SUBJECT: CCL 24/05/16 - COUNCIL SUBMISSION ON NEWCASTLE LIGHT RAIL REVIEW OF ENVIRONMENTAL FACTORS

Submission to Transport for NSW

Newcastle Light Rail Review of Environmental Factors (REF) 2016 Newcastle City Council

Figure 3 – Segregated Running along Hunter Street (TfNSW REF, 2016)

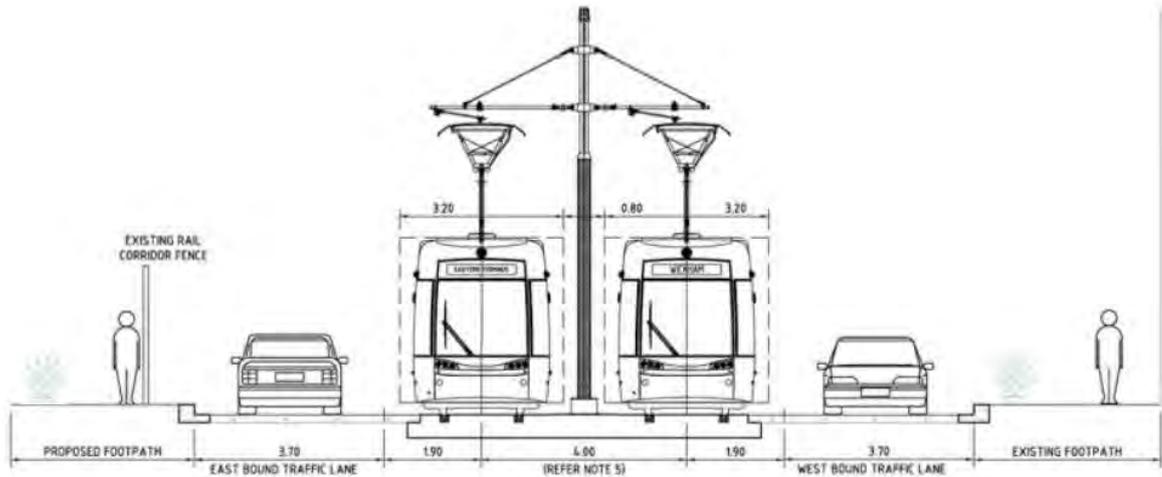
The separated running model described in the TfNSW REF will compromise the fabric and function of Hunter Street while removing any opportunity to provide cycle ways or accommodate pedestrian footpath widening along Hunter Street. This is illustrated in Figure 3 below:

It is evident in figure 3 above that no consideration is given to urban amenity and city operational issues such as pedestrian friendly design, footpath widening, cycleways, landscaping and parking. For the REF to identify that these critical issues will be addressed at a later date is an inappropriate response and is unacceptable to Council and the people of Newcastle.

Figure 5– Mixed Running (*Connecting Newcastle, 2016*)

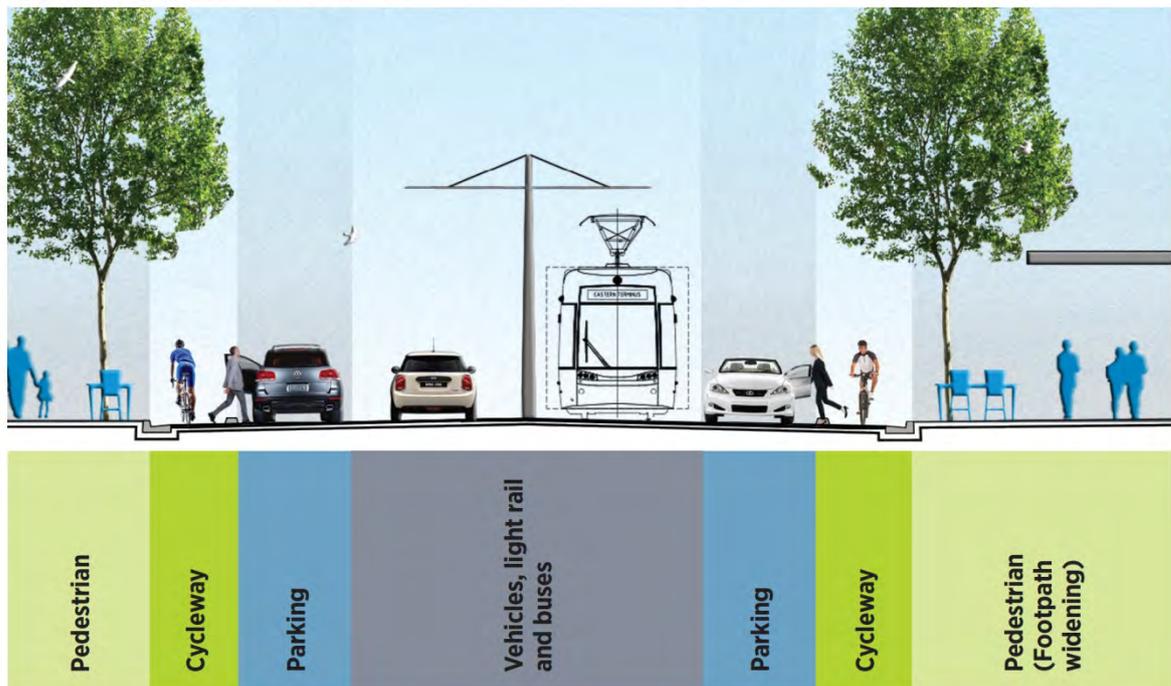
Council's preferred option, known as the Mixed Running Option, supports the REF option for light rail until Worth Place (provision of 600 metres of segregated running within the heavy rail corridor), followed by approximately 1300m of mixed running along Hunter Street, before a final 500 metres of mixed running within Scott Street, to Pacific Park or the loop option as outlined in *Connecting Newcastle 2016*.

Connecting Newcastle 2016 shows how this can be achieved through a simple change to a mixed running light rail system for Hunter Street section.

Figure 5 shows a cross section of how mixed running could work in Hunter Street.

Figure 6 – TfNSW versus NCC Preferred Operational Model for Light Rail

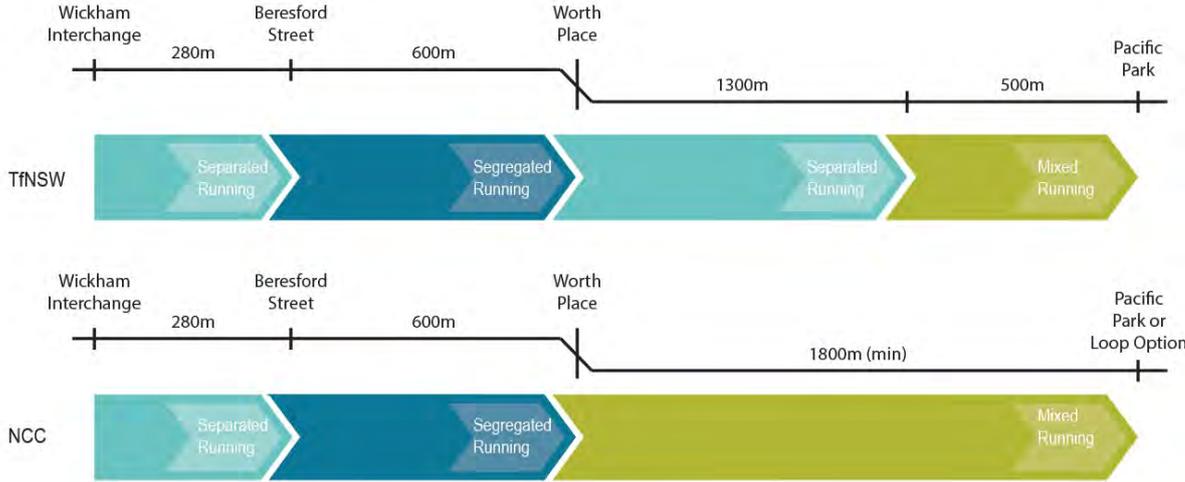
The operational model described in the TfNSW REF will involve 600 metres of segregated running within the heavy rail corridor from Wickham, followed by 1300 metres of separated running along Hunter Street, before a final 500 metres of mixed running within Scott Street. A comparison of the operational models is provided in Figure 6 below:

While the REF accepts mixed running for 500 m along Scott Street, its reasoning for discounting an additional section of mixed running along Hunter Street is unclear, lacks justification and has not been supported by a quantitative risk assessment. Section 5.5.2 of the TfNSW REF makes a comparison between mixed and separated running in an attempt to justify the 1300m of separated running along Hunter Street.
